FASEB - SPECIAL EXCEPTION CASE NO. S-862-B

SUBJECT: Special Exception request No. S-862-B  
Federation of American Society for Experimental Biology

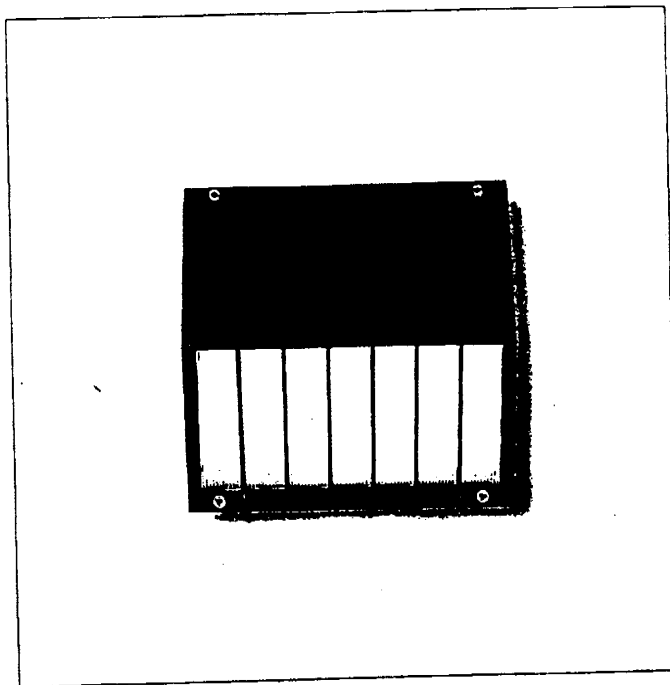
In response to the Board of Appeals hearing at which information was requested concerning the office building exterior lights, I would like to submit the following:

1. The exterior lights are "Bega", type 2479MH – shaded light source.
2. The fixtures will have a 100 watt lamp installed approximately 10'-0" above finished grade.
3. The fixtures have a shaded light source and the light will not extend beyond 20 feet from the building exterior.
